Access Compliance Report

Public Rights-of-Way

(Curb Ramps)

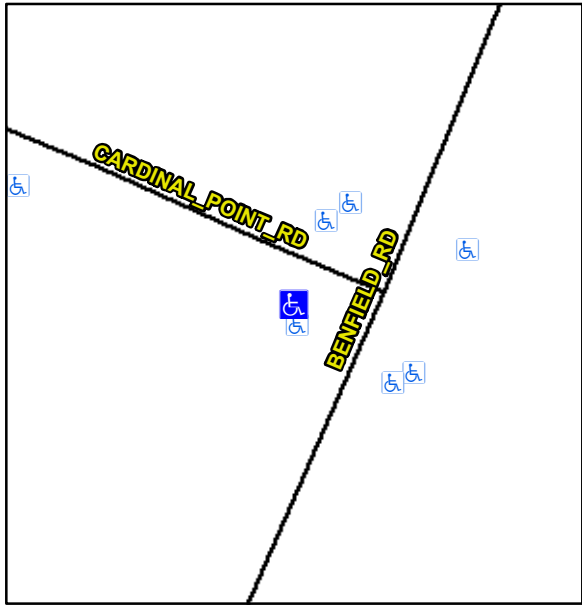
Intersection ID: 2853		Main Street: CARDINAL_POINT_RD		Cross Street: BENFIELD_RD		Location: SW																																																																																																																																																											
ADA ID: D91C66363EF2		Ramp Type: Directional1		Initial Pass/Fail: Pass		Overall Compliance: No		Severity Score: 7.5																																																																																																																																																									
Codes/Mitigation Info/Possible Solution				Field Measurements/Component Compliance																																																																																																																																																													
 Street 1 NameCARDINAL POINT RD Stop Condition-Street 1StopSign Street 2 NameN/A Stop Condition-Street 2N/A				Possible Solutions: Remove & Replace Entire Ramp. Remove & Replace Gutter. Surveyor Notes: N/A PROW/ADA: R304.2.2, R304.5.2, R304.2.3, R304.5.3

<table><tr><th>Compliance</th><th>Description</th><th>Data</th><th>Compliance</th><th>Description</th><th>Data</th></tr><tr><td>No</td><td>Ramp Slope (%)</td><td>8.4</td><td>N/A</td><td>Grade Break XSlope (%)</td><td>0.7</td></tr><tr><td>No</td><td>Flare Type LT</td><td>N/A</td><td>Yes</td><td>Flare Type RT</td><td>N/A</td></tr><tr><td>Yes</td><td>Gutter Lip Ht (in)</td><td>0.0</td><td>No</td><td>Gutter X Slope (%)</td><td>5.4</td></tr></table>
